PRE DEVELOPMENT APPLICATION LODGEMENT ADVICE

Application number	PRE-DA-31/2025
Applicant	Mirvac Residential (NSW) Developments Pty Ltd
Description of proposed development	Tree removal, site remediation (excluding works carried out as category 2 works), vegetation management and conservation, subdivision into residential lots (Stages 1-3) and super lots (Stages 4-7), construction of all civil works including excavation, civil and road and stormwater works across the site, delivery of 3 public parks, and construction of 49 dwelling houses.
Property	2A Bullecourt Avenue, MILPERRA NSW 2214, 2 Bullecourt Avenue, MILPERRA NSW 2214
Site Details	Lot 1 DP 101147, Lot 2 DP 1291984
Meeting Date	5 September 2025 – letter issued prior 3 September 2025

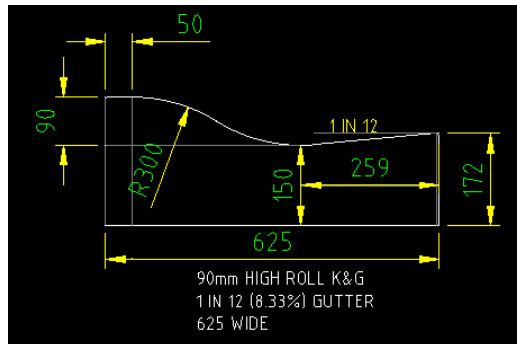
63. Roll kerb Fig 7 is superseded. New revised profile to be used as per the below;

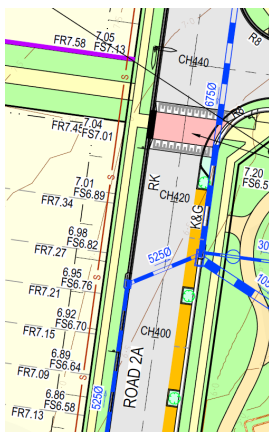
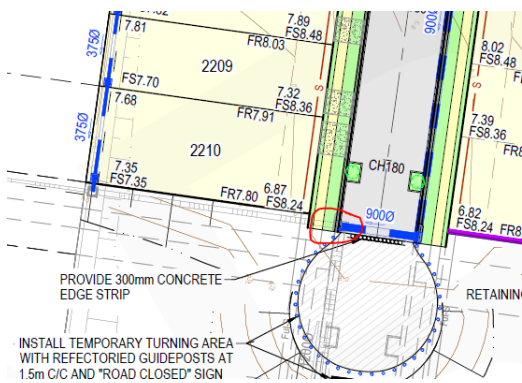
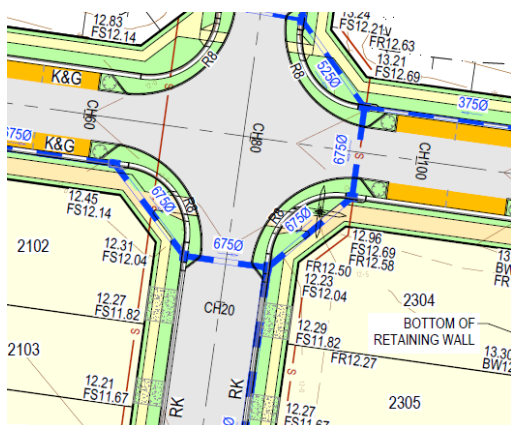
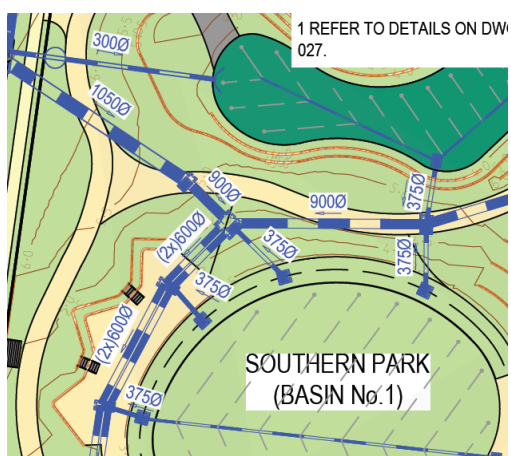
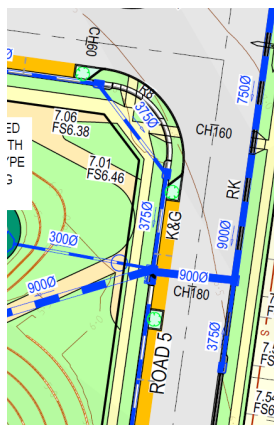
- a. Overall Stormwater Layout Plan shall be provided to show the entire stormwater drainage network, OSDs and water quality devices in the ultimate development scenario (inclusive of Stages 1 to 7)
- b. All drainage pipes crossing roads shall be angled at less than 90-deg, ideally 45-deg, if possible, to minimise hydraulic losses within the junction
- c. Drainage shall be provided to drain localised low point at Central Park (refer Drawing 052) and ChildCare (refer Drawing 054) below;

- d. Council advises against sharp angles, particularly changes in direction more than 90-degrees. All converging drainage pipes from opposite directions shall be avoided and realigned (refer Drawings 052, 053, 056)

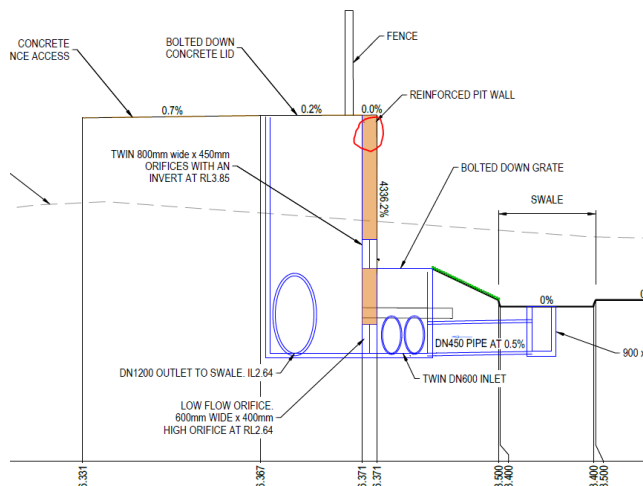
- p. AP Stormwater has concerns the complex basin outlet design is prone to sedimentation
- q. Suggest providing a higher orifice outlet for Basin No. 1 outlet (circled in red as follows)
